REMARKS

This Amendment is submitted in response to the Office Action mailed May 10, 2005. In the Office Action, the Examiner has acknowledged Applicant's election without traverse of Group 1 (claims 1-21), Species C (claims 10-13), and has withdrawn claims 8, 9, and 22-35 from further consideration pursuant to 37 CFR 1.142(b) as being drawn to a nonelected invention and species. Also in the Office Action, the Drawings, Specification, and Claims were objected to for various informalities, Claims 1-4, 10 and 16-19 were rejected as being anticipated by US Patent No. 3,752,474 to Macabet et al. ("Macabet"), Claims 1 and 21 were rejected as being anticipated by US Patent No. 5,433,688 to Davies ("Davies"), Claim 20 was rejected as being unpatentable over Macabet in view of US Patent No. 6,258,011 B1 to Wolfe ("Wolfe"), Claims 14 and 15 was rejected as being unpatentable over Macabet in view of US Patent No. 4,060,240 to Dunston ("Dunston"), Claims 1-7, 16, 18, and 19 were rejected as being unpatentable over US Patent No. 5,352,172 to Suzuki ("Suzaki") in view of US Patent No. 5,217,029 to Shields ("Shields"), and Claims 1 and 10-13 were rejected as being unpatentable over BODYBUILDER'S

FIG. 12B

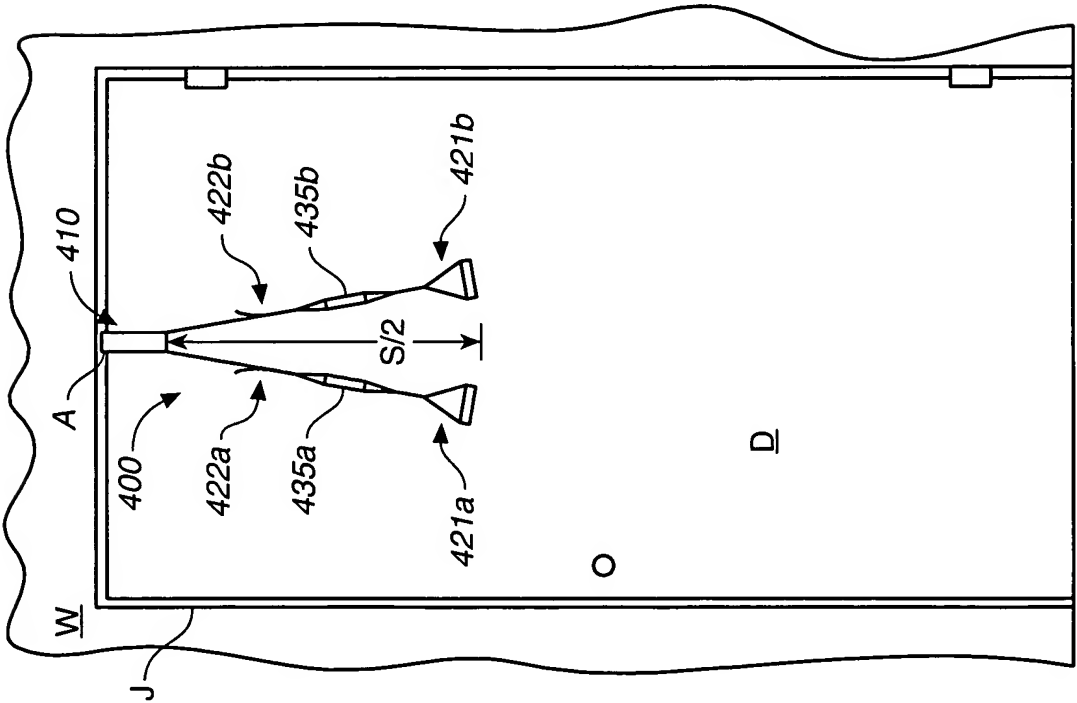
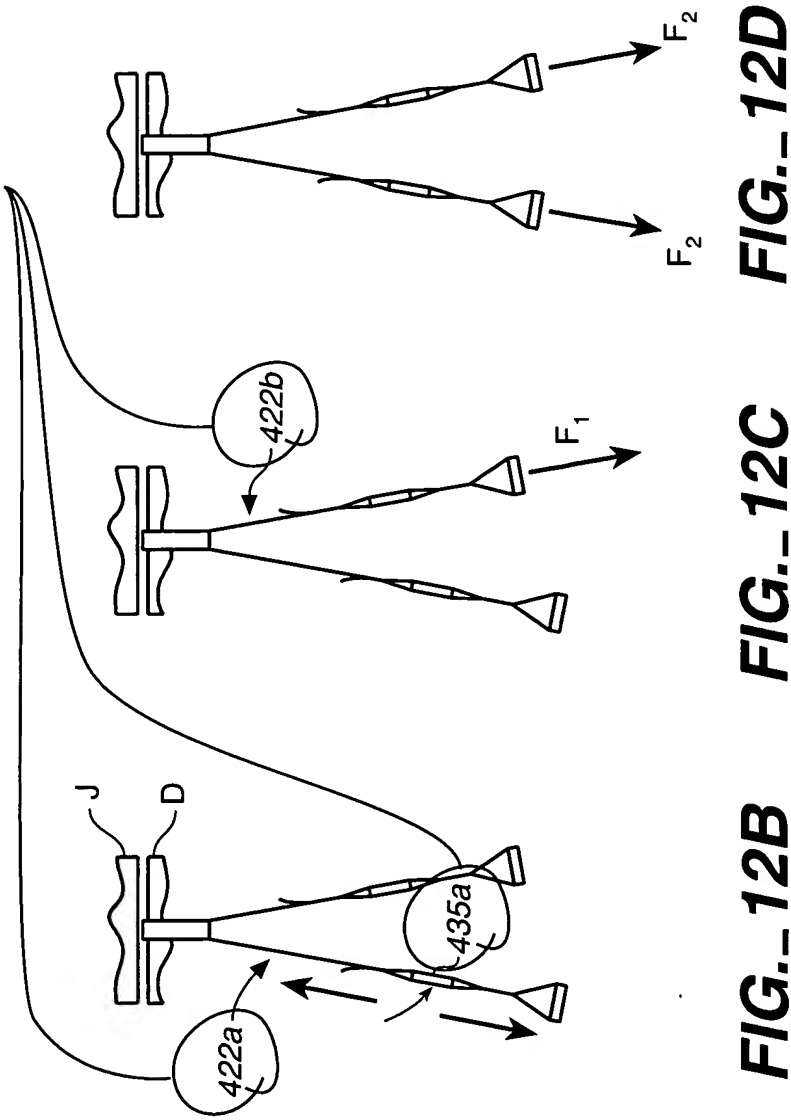
Replacement Sheet 8, which includes FIGS. 12A, 12B, 12C, and 12D, has been amended to include reference numerals 422a, 422b, and 435a in FIGS. 12B and 12C, and Replacement Sheet 10, which includes FIGS 13A, 13B, and 13C, has been amended to include reference numerals 410, 422a, 422b, 435a, and 425b in FIGS. 13A, 13B, and 13C. Changes to Replacement Sheets 8 and 10 in compliance with 37 CFR §1.121(d) and are indicated in the attached Annotated Sheet Showing

3) Changes to FIG. 12B and 12C in Replacement Sheet 8. This sheet, which includes FIG. 12A, 12B, 12C, and 12D, replaces the original sheet including FIG. 12A, 12B, 12C, and 12D. In Figures 12B and 12C reference numerals 422a, 422b, and 435a have been added as noted in the attached Annotated Sheet Showing Changes.

Reference
numerals
added

FIG. 13A

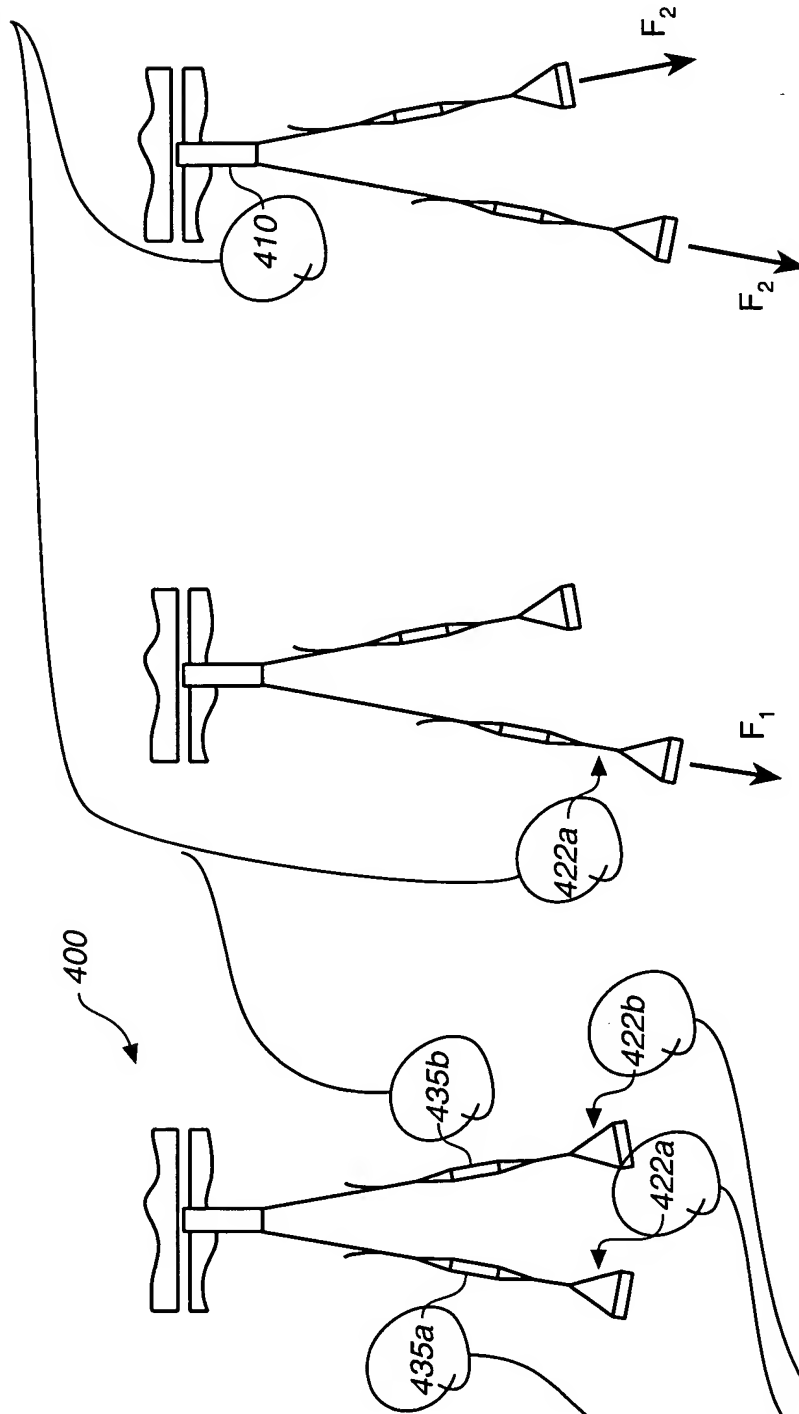
4) Changes to FIG. 13A, 13B, and 13C in Replacement Sheet 10. This sheet, which includes FIG. 13A, 13B, and 13C, replaces the original sheet including FIG. 13A, 13B, and 13C. In Figures 13A, 13B, and 13C reference numerals 410, 422a, 422b, 435a, and 425b have been added as noted in the attached Annotated Sheet Showing Changes.

Reference
numerals
added

FIG. 25

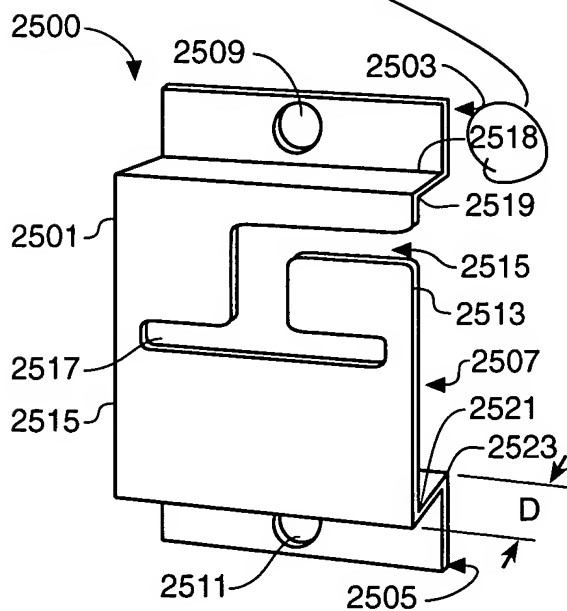
The Drawings were objected to for failing to comply with 37 CFR §1.84(p)(4) for using the reference character “**2517**” for two elements of bracket **2500**. This objection is the result of a typographical error in number crease **2517**. In response, Applicant has amended FIG. 25 in compliance with 37 CFR §1.121(d) and paragraph [0075]. A Replacement Sheet 24 of the Drawings and an Annotated Sheet Showing Changes is included herein. FIG. 25 and paragraph [0075] have both been amended to change crease **2517** to crease **2518**. No new matter has been introduced with these amendments.

5) Changes to FIG. 25 in Replacement Sheet 24. This sheet, which includes FIG. 24-26, replaces the original sheet including FIG. 24-25. In the original Figure 25 the reference numeral 2517 was used to number two elements. In the Replacement Sheet, crease 2517 has been relabeled "2518", as noted in the attached Annotated Sheet Showing Changes.

Reference
numeral
corrected
